**Town of Kittery
Planning Board Meeting
November 17, 2016**

450 U.S. Route 1 – Site Plan Review

Staff Review

From: Jodie Bray Strickland <jstrickland@cmaengineers.com>
Sent: Wednesday, November 09, 2016 4:44 PM
To: Chris DiMatteo; William Straub
Cc: Rebecca Spitko
Subject: RE: 450 US rt 1 (dominos)

Sheet:
L-1

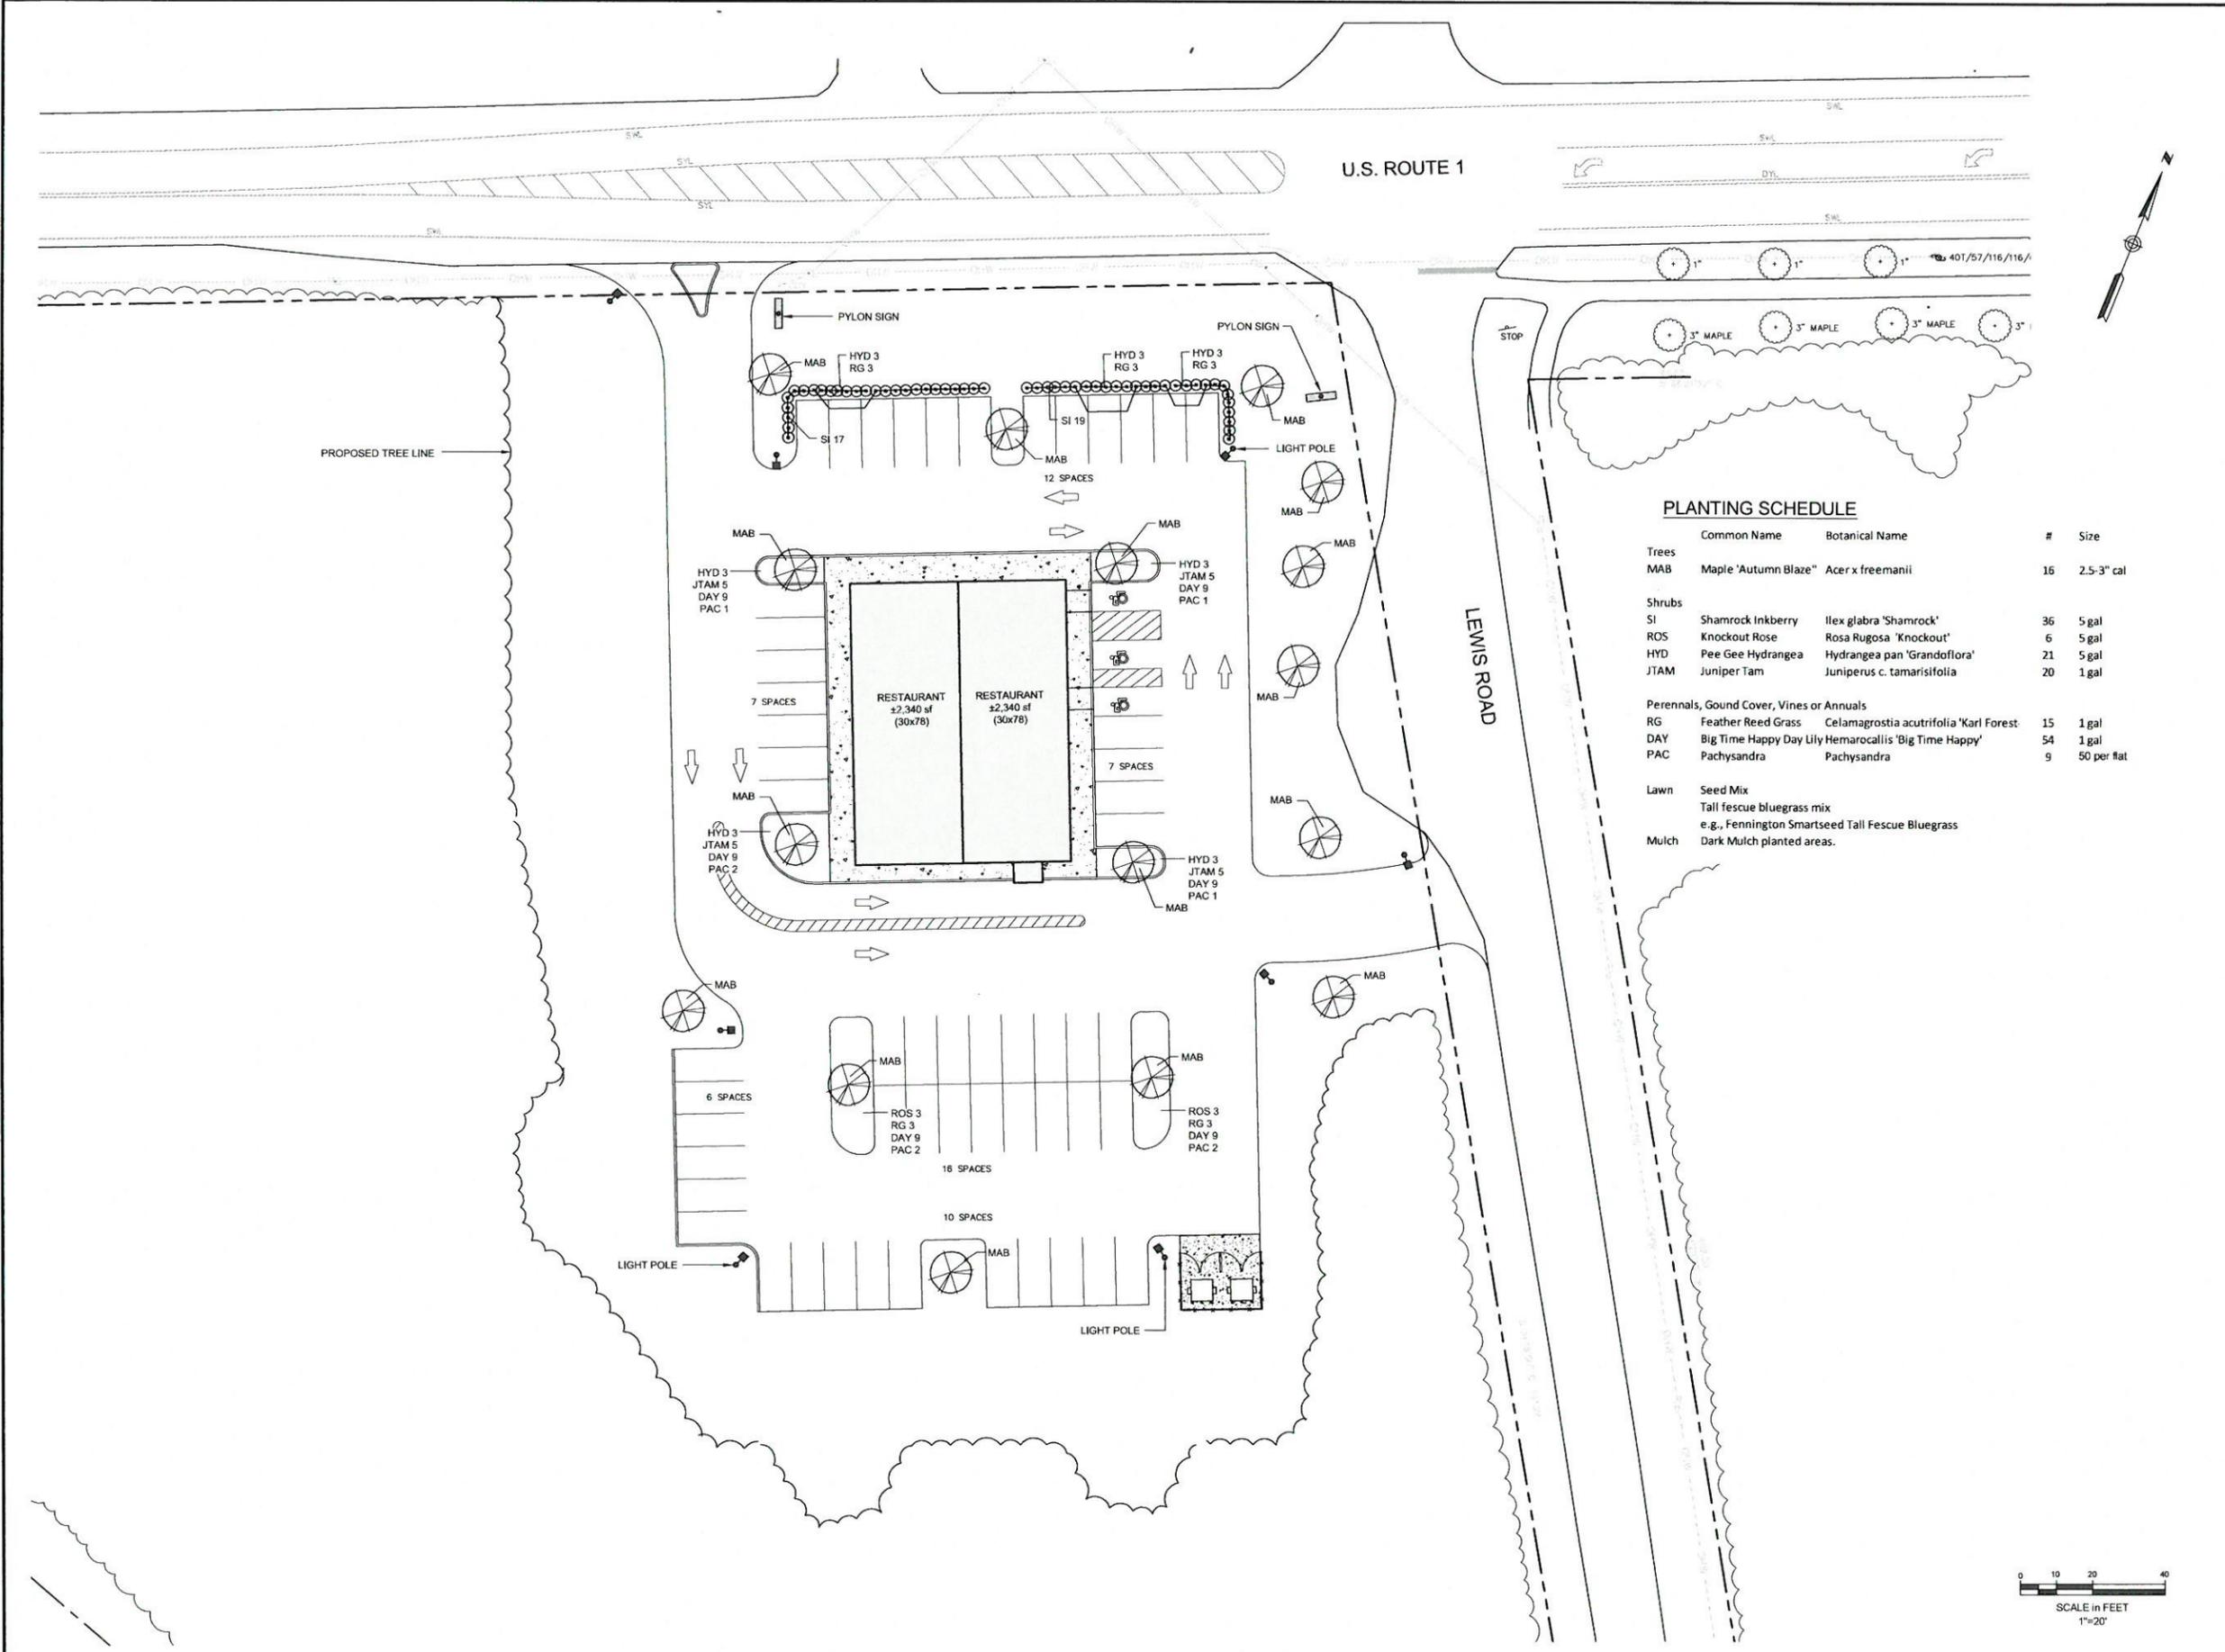
10. Landscape plan (L-1) outlines a proposed onsite planting schedule. The proposed planting does not meet the minimum planting requirements for the Mixed Use zone, 16.3.2.13.D.6 (shrubs and flowering perennials a minimum of 10 plants per 40-linear feet of street frontage and street side trees 1 tree for each twenty-five feet of frontage) or screening requirements in 16.3.2.13.D.4. The required street side trees (for approx. 1,500 feet of frontage), however, may be reduced if large existing trees are preserved. Given the large lot size as compared to the total area proposed to be developed, the Board may find it reasonable to consider the preservation of existing vegetation adjacent to the development envelope count toward this requirement. In addition, another review of the proposed grading may reveal some accommodation for preserving existing trees within the limits of developments. In either case the applicant needs to revise the planting plan and demonstrate compliance to the Mixed-Use design standards referenced.

- D.6.a.i. It is not clear that the landscape planter strip is entirely vegetated.
- D.6.a.ii. It is not clear that the required number of street trees have been provided. Additionally, some of the proposed Maple Autumn Blaze are located on a sloped area northwest of the driveway.

- D.6.a.ii. It is not clear that the required number of shrubs and flowering perennials required have been provided.
- D.8. Open Space is not designated on the plans.

1. Revise the plan to depict 10 or fewer spaces between the principal building and front lot line.
2. Revise the landscape plan to conform with the design standards.
3. Relocate the sign currently located at the corner of Lewis Road and Route 1.
